Subject: Submittal of the Phase II Investigation Work Plan for Sandia Canyon

Phase II Investigation Work Plan for Sandia Canyon

*Crosswalk of New Mexico Environment Department
Approval with Modifications for the Sandia Canyon
Investigation Report with the Phase II Investigation Work Plan
for Sandia Canyon*

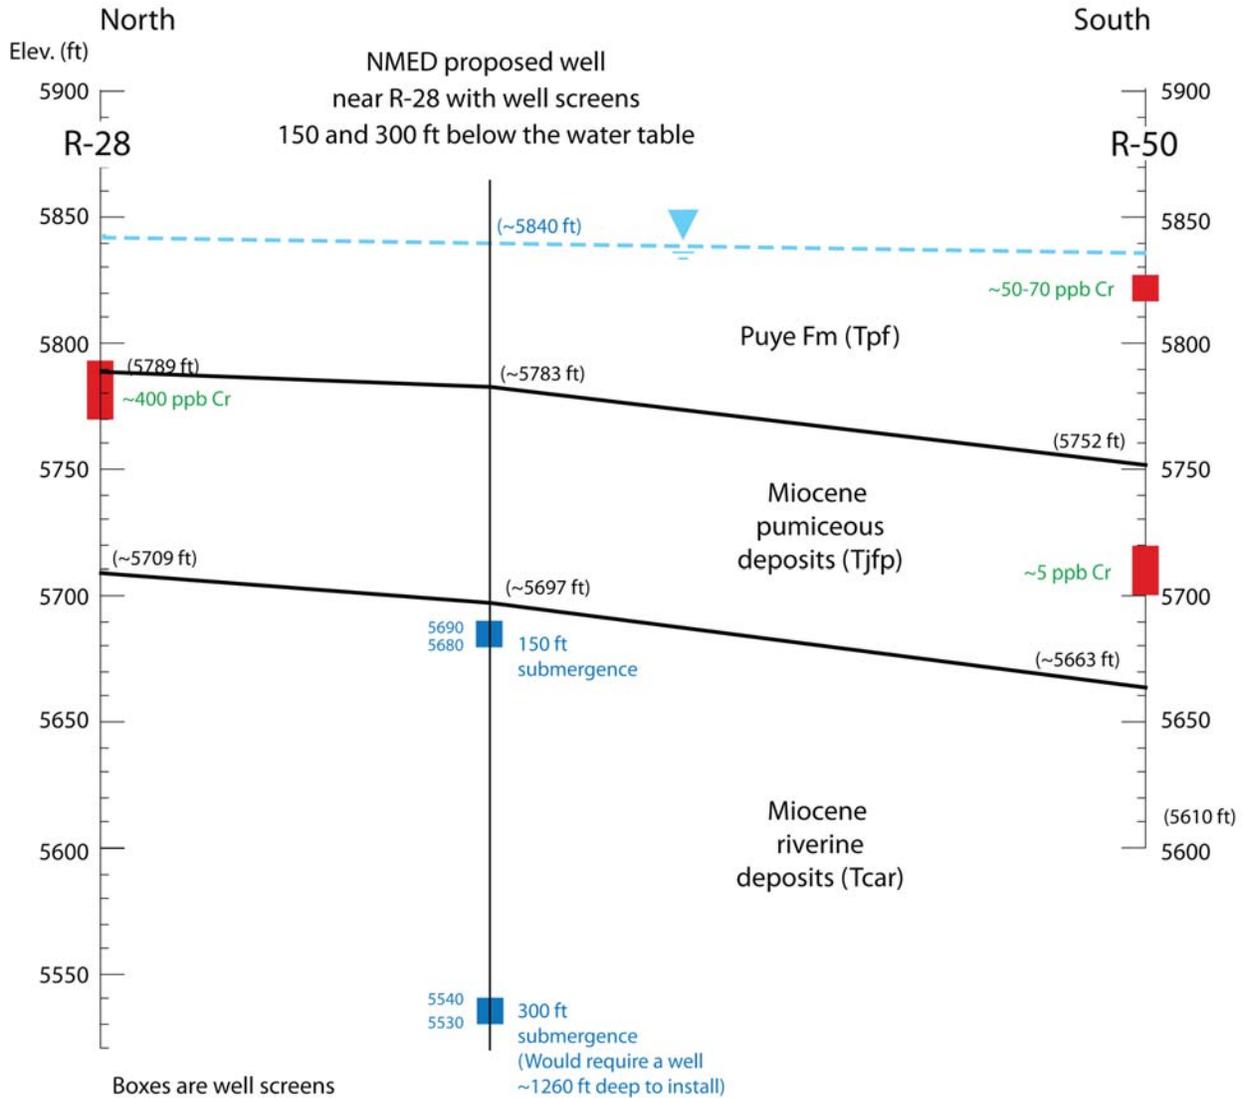
NMED Comment No.	Summary of NMED Comment and Requirement	LANL Proposed Action	Rationale for Proposed Action if Different from NMED Requirement
3	<p>The vertical and western extents of the chromium plume in the regional aquifer are not adequately defined.</p> <p>LANL will install a dual-screen well at depths of 150 and 300 ft below the water table in the regional aquifer at well R-28 to define the vertical extent of contamination and will also install a second dual-screen well west of well R-42 on the mesa separating Sandia and Mortandad Canyons.</p>	<p>Two regional aquifer wells are proposed in this work plan (section 4.2). The well locations are shown in Figure 4.2-1.</p> <p>The location for well R-61 has been changed from the original NMED requirement to define the vertical extent of contamination near well R 28. The new proposed location and dual-screen design for well R-61 reduce uncertainty about the nature and extent of chromium contamination in light of recent observed chromium concentrations detected at newly installed well R-50, and they help to delineate the vertical extent of chromium contamination at that location.</p> <p>A second dual screen well, R-62, will be installed west of well R-42 on the mesa separating Sandia and Mortandad Canyons, in accordance with NMED's requirement.</p>	<p>Recent data from newly installed well R-50 shows that chromium is present at or above regulatory standards in the upper part of the regional aquifer near the LANL boundary with San Ildefonso Pueblo, potentially indicating a southerly component of groundwater flow different from that predicted by groundwater gradients alone or possibly additional breakthrough points or sources of chromium. As discussed with NMED at a meeting on June 3, 2010, these new results highlight important uncertainties about conceptual models for chromium migration. These uncertainties are discussed in section 3 of this work plan. Monitoring data from existing dual-screen wells, including R-50, provide good evidence that chromium migration occurs in the upper part of the aquifer and that the vertical extent of chromium is sufficiently constrained by the existing network of wells (see Figures A-1 and A-2).</p> <p>The proposed well R-61 will further define the nature and extent of chromium contamination south of well R-42 by installing a dual-screen well that monitors groundwater at the water table and approximately 100 ft below the water table. The proposed location for well R-61 will provide key information about contaminant distributions and water chemistry that will be important for evaluating the conceptual model uncertainties for the chromium infiltration pathway, migration within the regional aquifer, and a potential additional source, as discussed in section 3.</p>
